Lic #DPR-58 & DPR-74 Appl for Amend to increase spent fuel storage capacity from
 500 to 2,050 fuel assemblies. W/encl description, safety analysis & environ considerations.

Donald C. Cook Nuclear Plant Units 1 & 2
Docket Nos. 50-315 and 50-316
License Nos. DPR-58 and DPR-74
Spent Fuel Storage Capacity Expansion

Donald C. Cook Nuclear Plant Unit No. 1
Docket No. 50-315
DPR No. 58

Changes are hereby requested to the Donald C. Cook Nuclear Plant Unit No. 1 Appendix A Technical Specifications in Sections 3.2 and 4.2 (Power Distribution Limits) and the corresponding bases. The purpose of this change is to extend the heat flux hot channel factor limit (F_Q) to higher reactor exposures than is currently provided for in the Technical Specification. The current F_Q limit is applicable for Cycle 2 exposure up to 10,800 MWD/MTU. Planned operation for the balance of Cycle 2 may exceed this exposure. Also the F_Q limit must be revised to be applicable to future cycles.

FIGURE 3.2-3 EXPOSURE DEPENDENT F_Q LIMIT, $F_Q^L(E)$, AND NORMALIZED LIMIT $T(E)$ AS A FUNCTION OF PEAK PELLETT BURNUP

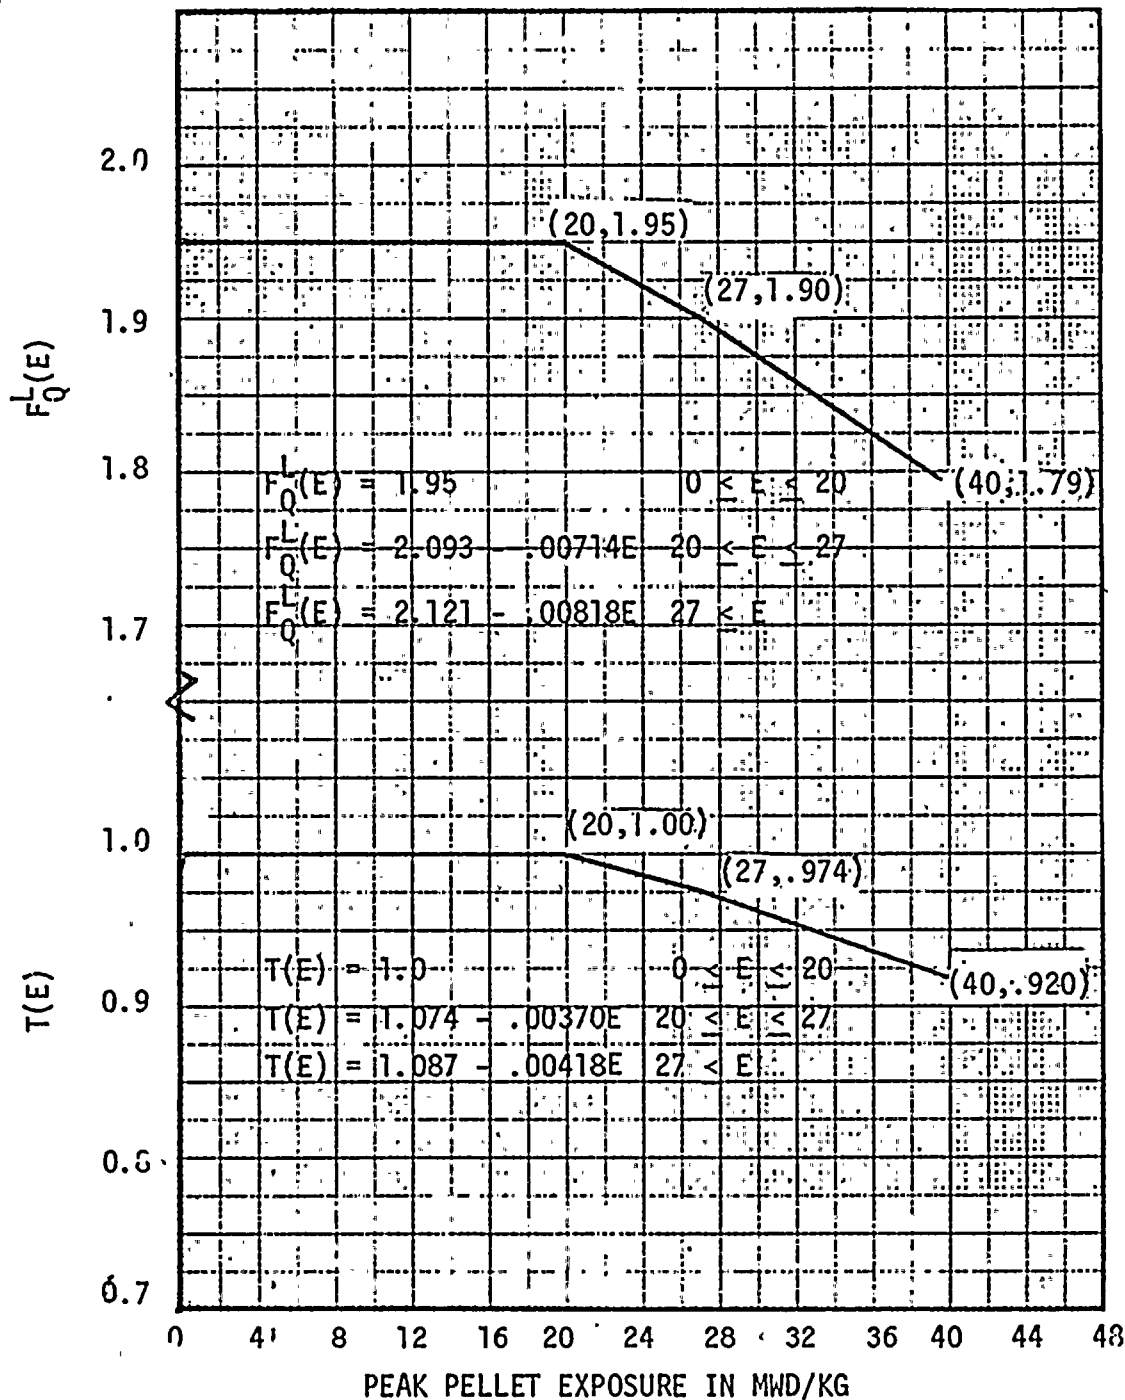
$F_Q^L(E_k)$ = The exposure dependent F_Q limit on the maximum linear heat generation rate for fuel segment k. $F_Q^L(E)$ is defined in Figure 3.2-3.
